Amendments to the Drawings:

REMARKS

"Annotated Sheet"

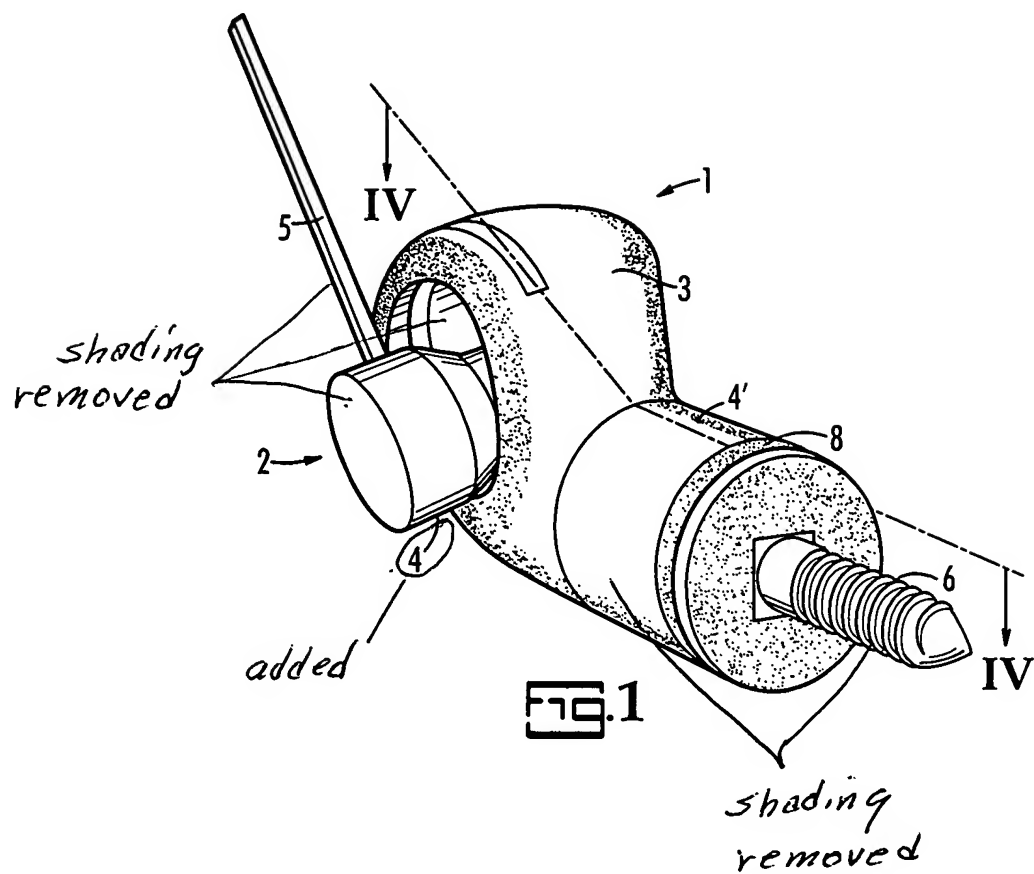
The attached 2 new sheets of drawings, each labeled “replacement sheet” replace the original 4 sheets of drawings.

New drawings are provided to comply with the Examiner's requirement. The described and claimed features are now believed to be fully illustrated.
